**Subject:** Response to U.S. EPR Design Certification Application RAI No. 442, FSAR Ch. 7, Supplement 13

**Question 07.03-32:**

After reviewing the applicant's response to RAI 285, Question 07.03-27, the staff requests the applicant to explicitly identify in Chapter 7 which Protection System (PS) manual functions are credited in the safety analysis.

Figure 7.3-20—Containment Isolation

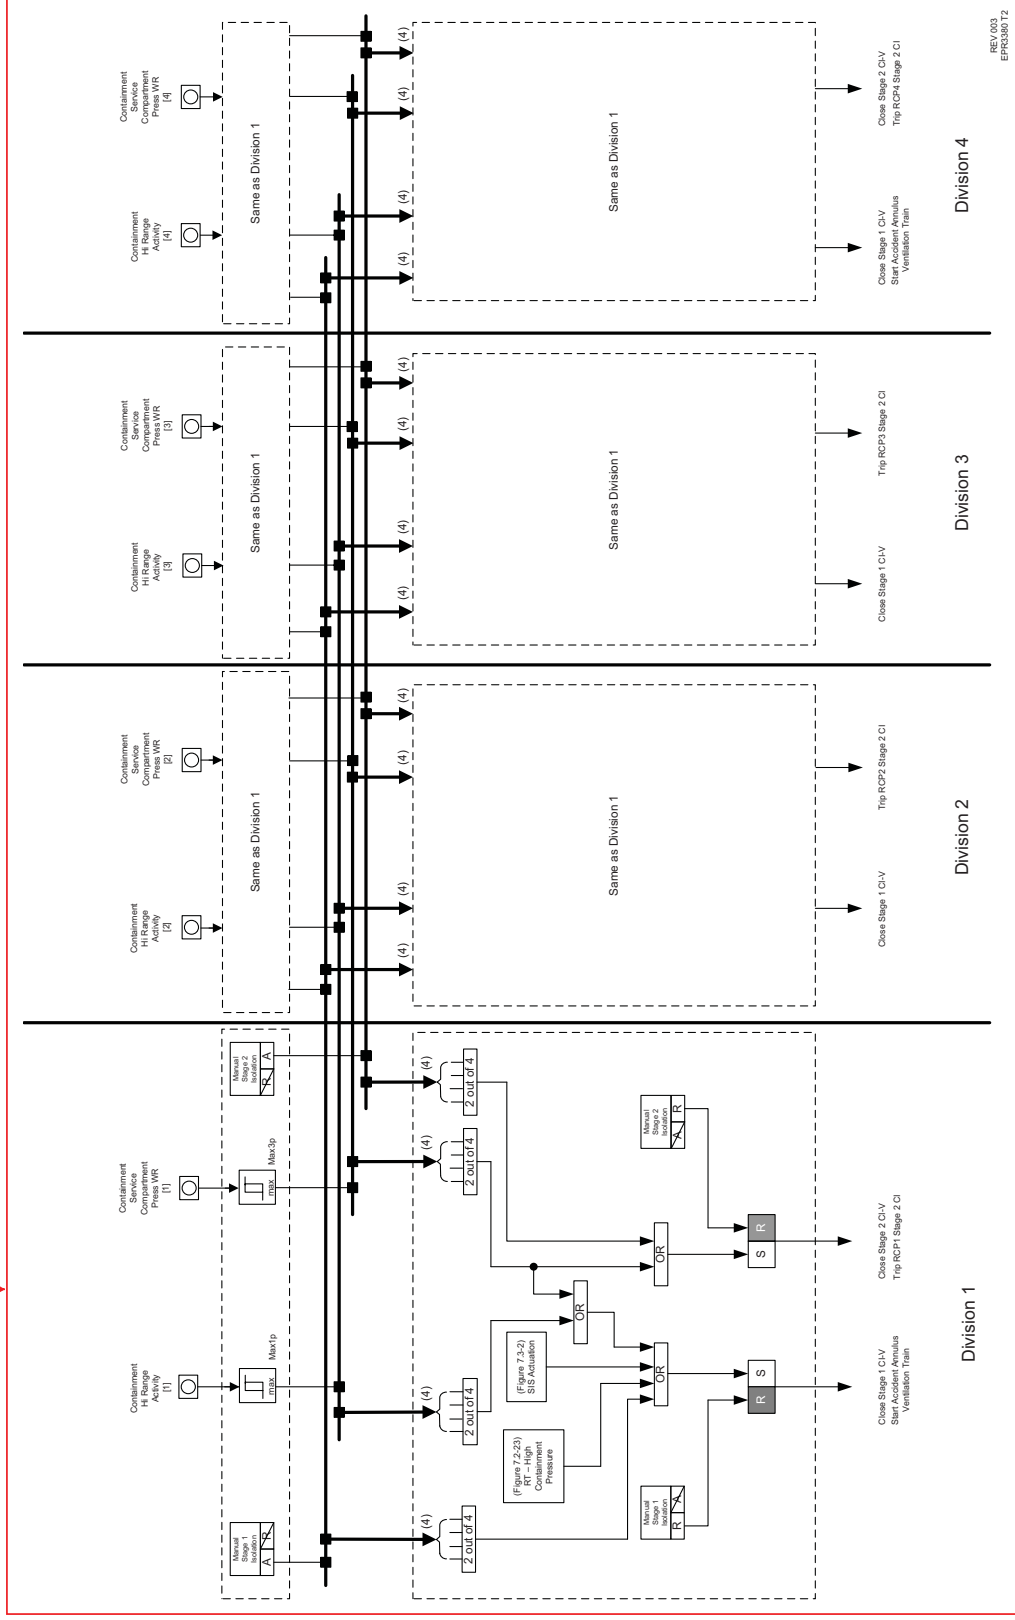
07.03-32

Figure 7.3-27—RCP Trip

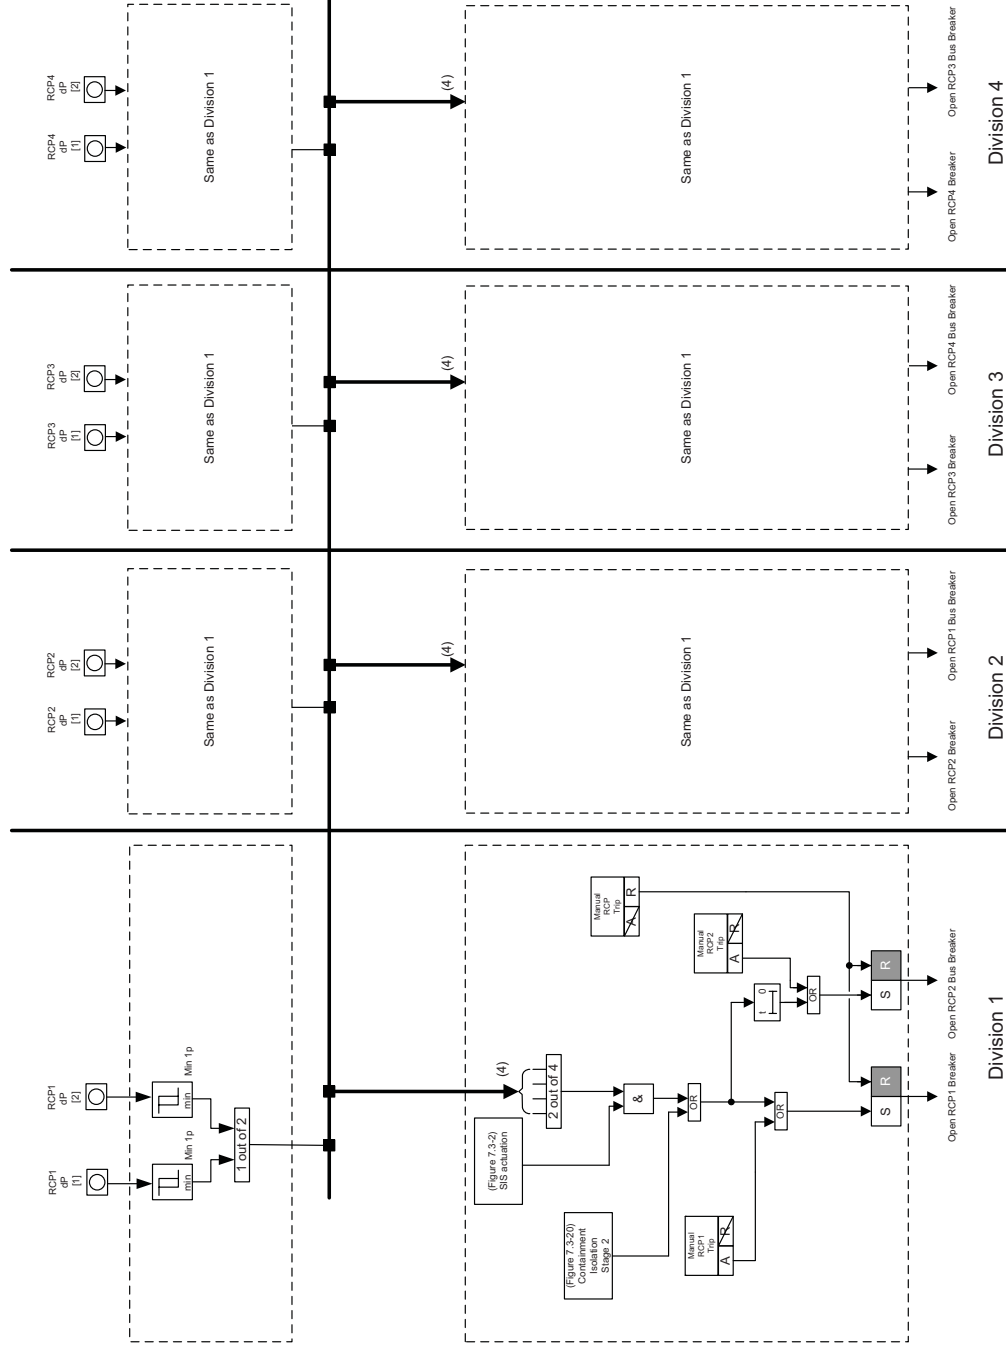
07.03-32
